CERTIFIED SURVEY NO. 1578  
DOCUMENT NO. 1414996

Plat of Survey  
D'ONOFRIO, KOTTKE AND ASSOCIATES, INC.  
MADISON, WISCONSIN

**From:** Mancheski, Jean - DOT [jean.mancheski@dot.wi.gov]  
**Sent:** Thursday, February 13, 2014 10:09 AM  
**To:** Quamme, Jeff; Anderson, Patrick  
**Cc:** Tucker, Matthew; Pederson, Eric  
**Subject:** RE: 6301 Odana/CSM 1578

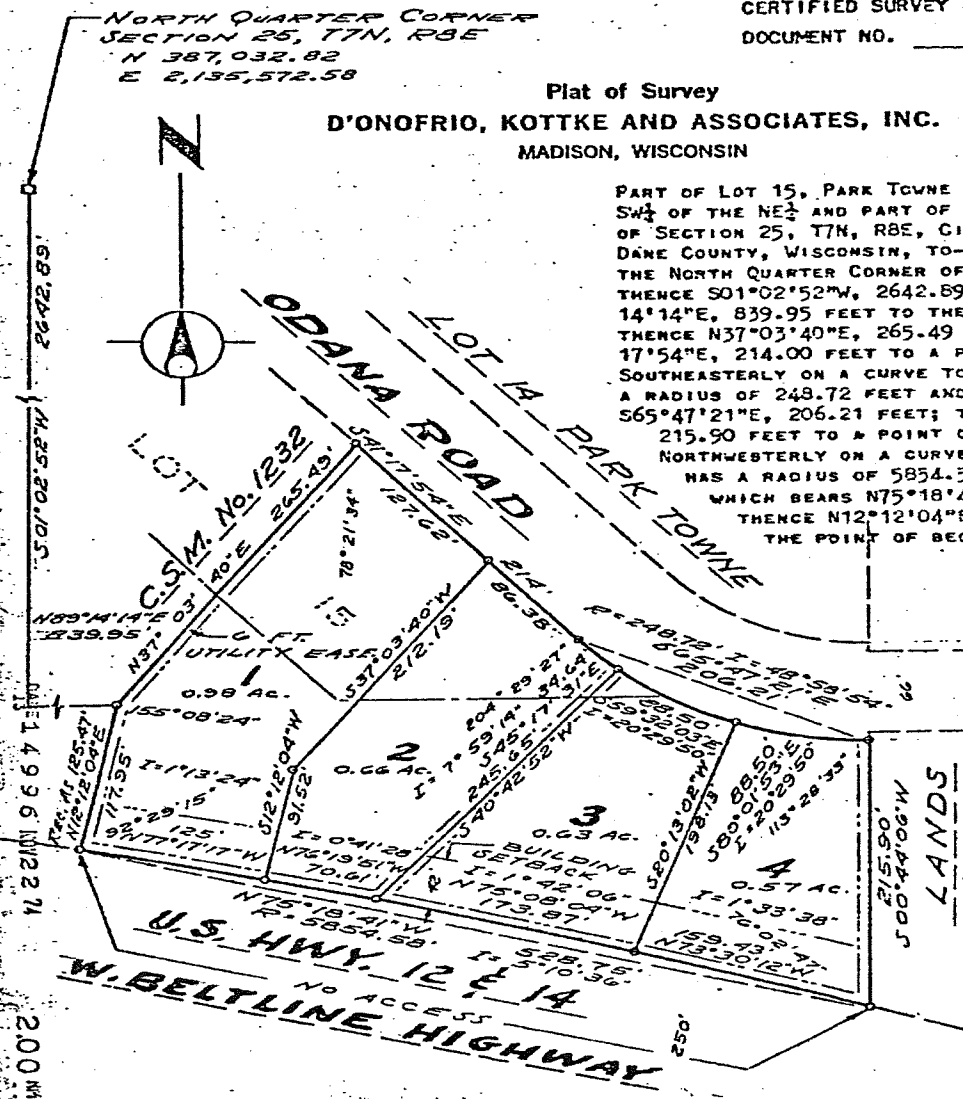
see attached email from DOT. Building setback line is not enforceable by the DOT

Attached is an older Certified Survey Map (1578) in the City of Madison. CSM's at the time of recording were not submitted to the DOT for review. But there is a 42' building setback line (not denoted a highway setback line) shown on the Certified Survey Map.

Proposed development on the property(s) would require the release of the 42' setback line.

Before the discussion goes much further, we would like to confirm whether this is a setback enforced by the DOT or not. My inclination is it is not, but would prefer to make sure before moving ahead.

Will the 42' setback be eliminated as a result of a new CSM? The existing lot lines will go thru the new building addition, CSM will combine lots 3 & 4. If lot 2 is required to be rezoned, then they will include it in the 1 lot CSM. Will they need the cross access agreement if lot 2 is not included?

There is not any indication of this being a setback line required specifically by the DOT in any certificate or in the notes for the setback itself. HY 33 (now TRANS 233) did have setback requirements, see section 33.08, but again it would have applied to platted areas only and not CSM's.

The 42' setback from the beltline the CSM? If St. Vinneys would like to do an addition to their building showing a setback of less than 42'. Is this something that is commonly done? Will this require a Counsel resolution action to amend the existing CSM or a new CSM? Do you have a contact at District 1? We will likely see them at DAT as the addition will include the demo of The Leather Furniture Place for parking?

Based upon the documents that WisDOT reviewed, I am unable to verify that WisDOT imposed the setback on the plat of survey.

That being said...the Beltline is a major highway and it is quite likely that the r/w will be expanded at some point in time. Therefore in an effort to protect all parties involved, WisDOT would like to respectfully caution the City as to what you choose to allow in the setback area.
